REGIONAL MUNICIPALITY OF OTTAWA CARLETON
 MUNICIPALITÉ RÉGIONALE D'OTTAWA CARLETON

REPORT
RAPPORT

DATE 13 February 1998

SUBJECT/OBJET **CENTRETOWN TRAFFIC CALMING PLAN AND KENT
 STREET TRAFFIC CALMING CONCEPT PLAN**

**Preferred
Kent Street
Traffic Calming
Concept Plan**

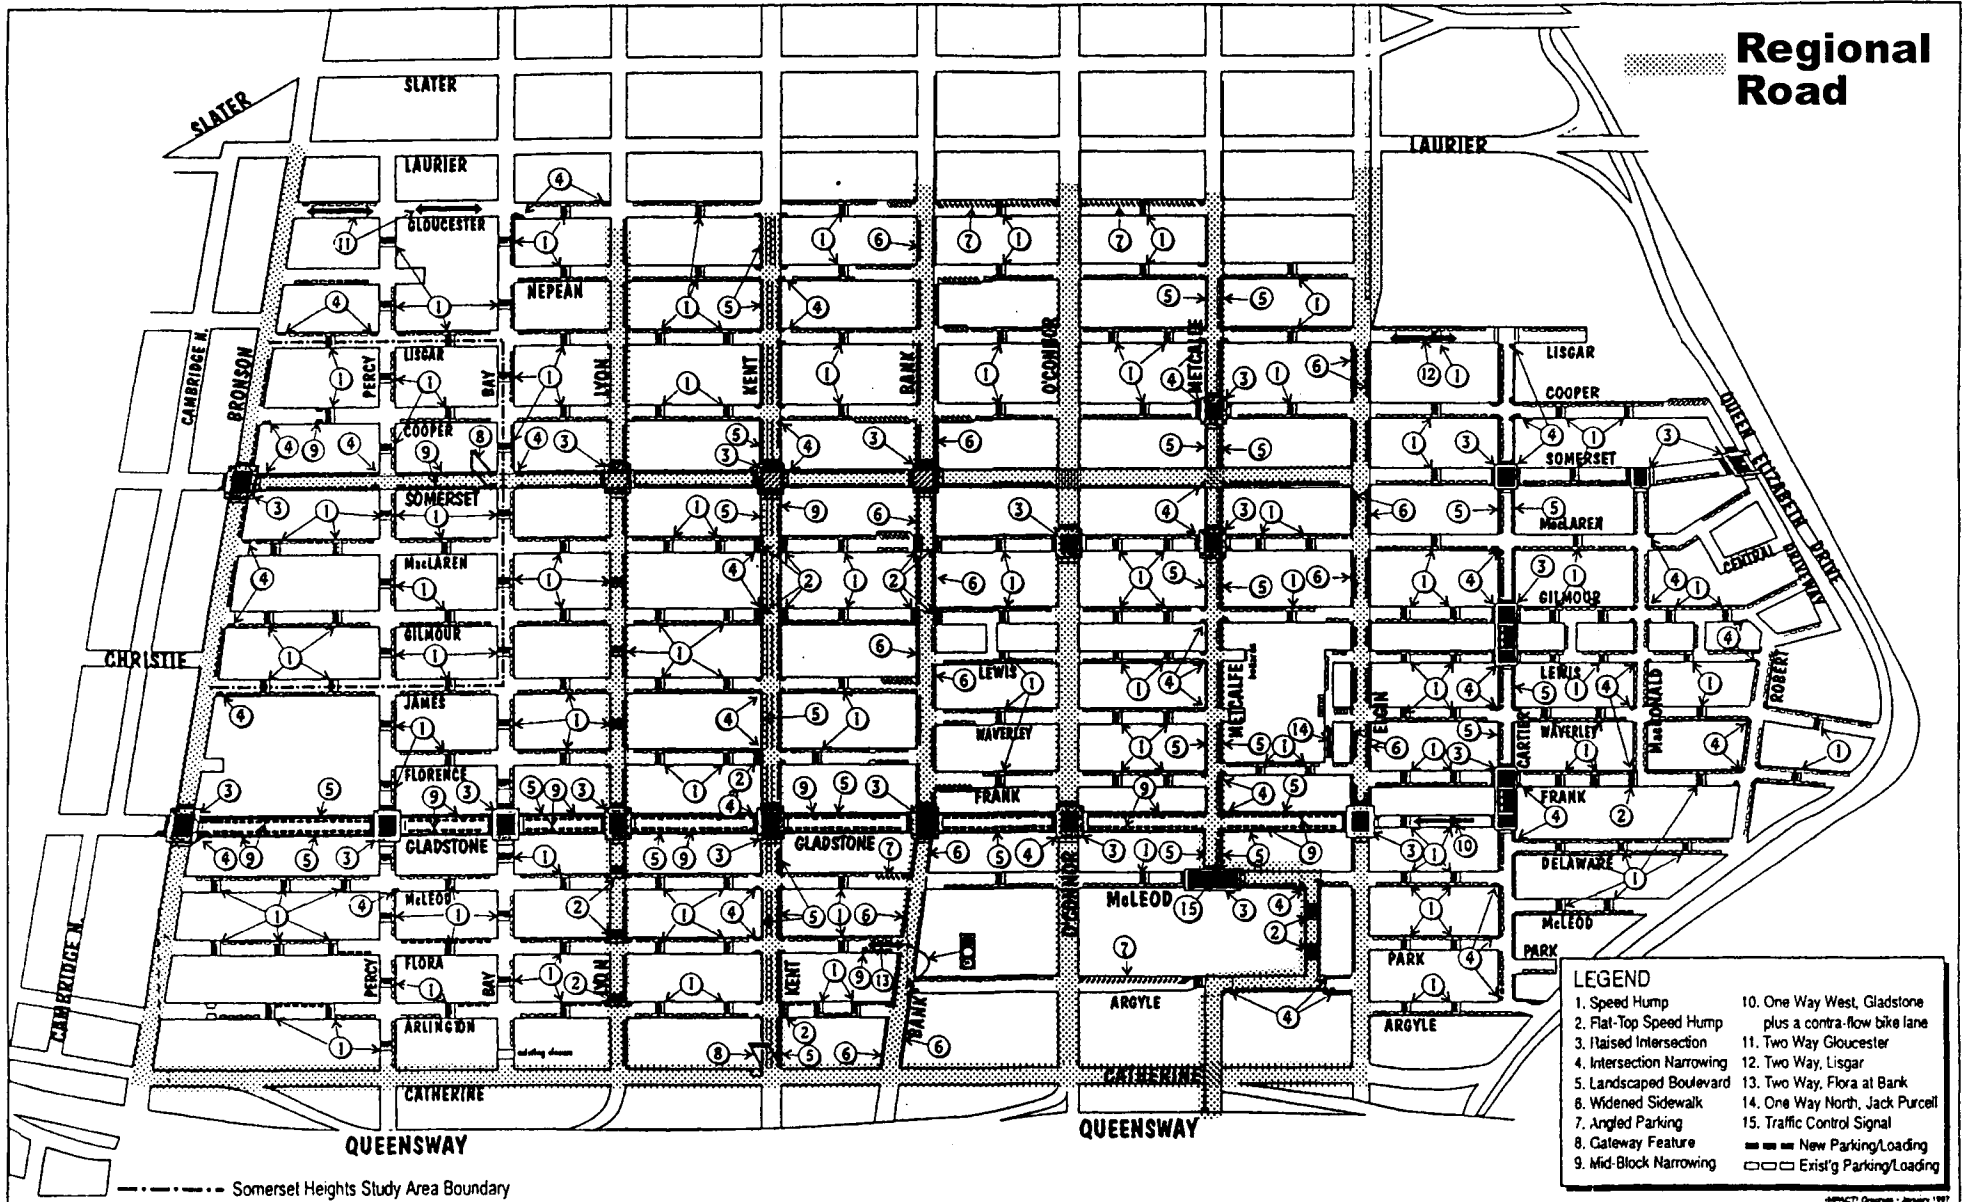
The Kent Street concept plan illustrated in Annex A provides an appropriate and acceptable concept plan to proceed with final design and implementation as priorities and funds dictate. The raised intersections illustrated for the intersections with Somerset Street and Gladstone Avenue are cause for concern on major arterial streets such as Kent Street, since they may have adverse impact on emergency vehicle and bus operations, and will require extra maintenance. These measures should not be implemented until the pilot project for Kirkwood and Churchill Avenues is assessed.

- 2. that, subject to technical evaluation, detailed design, and the identification of capital and operating funds, the *Preferred Kent Street Traffic Calming Concept Plan* as illustrated in Annex A and Figure 5.2 of the consultant's report be approved;**
